DRAWINGS

BARBARA JORDAN ELEMENTARY SCHOOL – ADDITIONS & RENOVATIONS
AISD PROJECT # 180011-JORDN
SMITH & COMPANY ARCHITECTS

12.07.18 ADDENDUM

A8.10

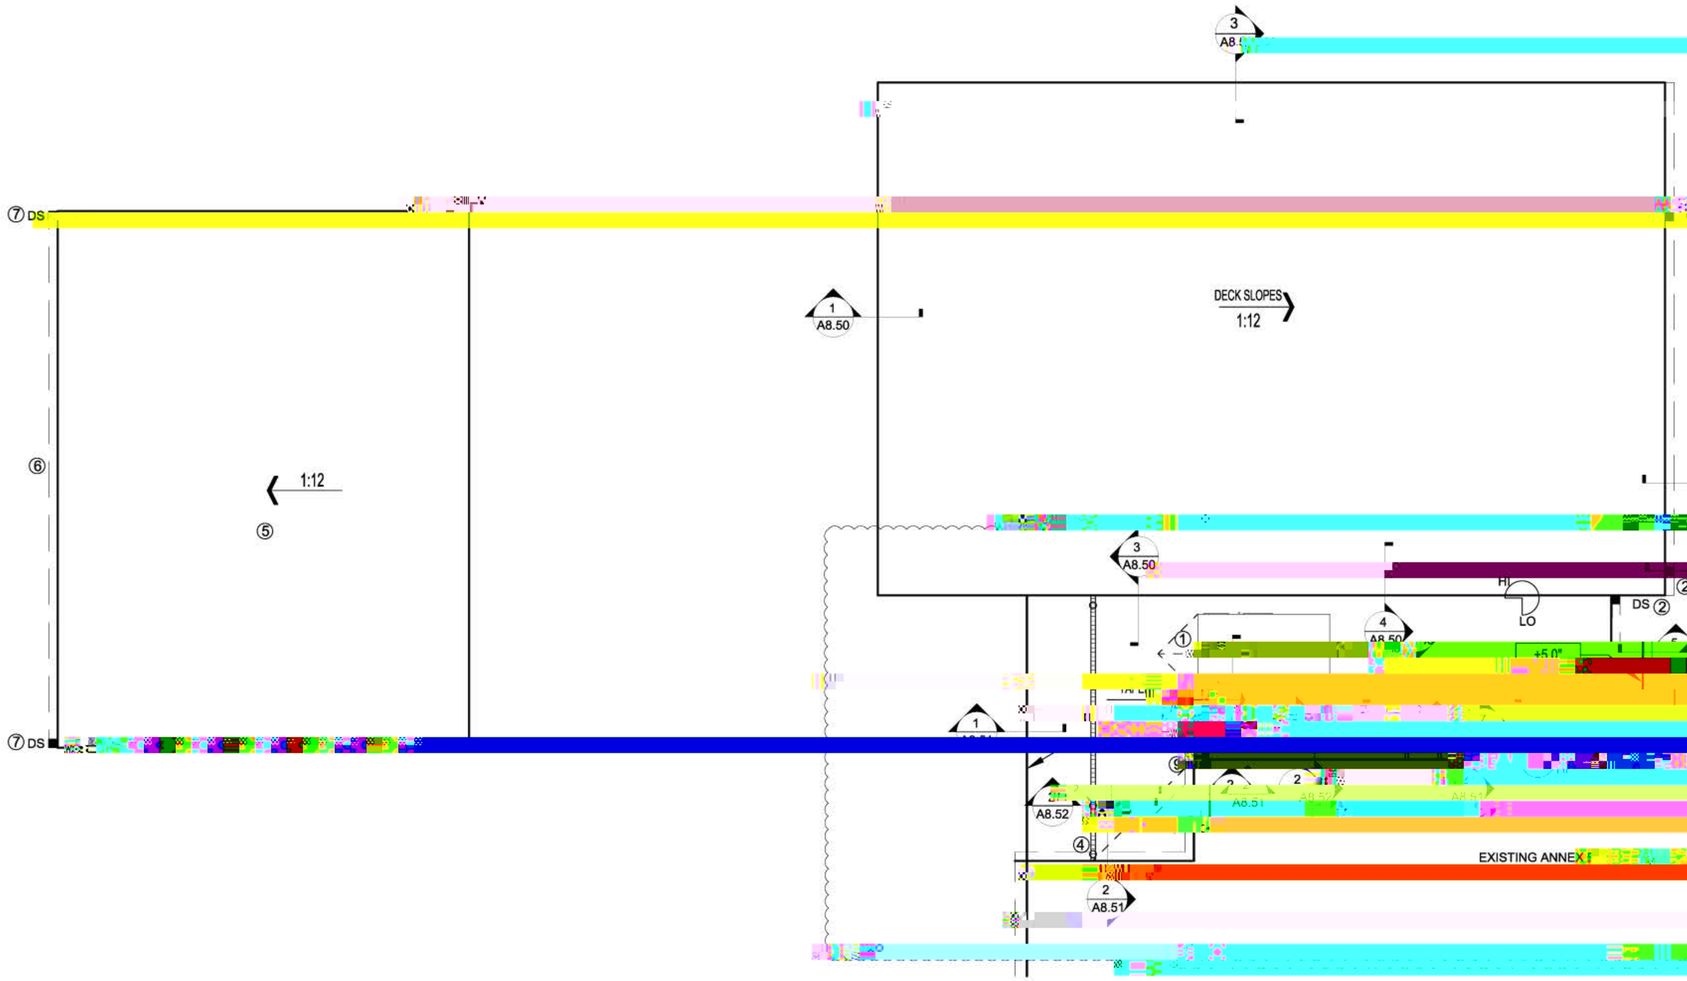
2. Delete Sheet A.10 ROOF PLAN dated October 22, 2018, and replace with attached sheet A.10 dated December 07, 2018.
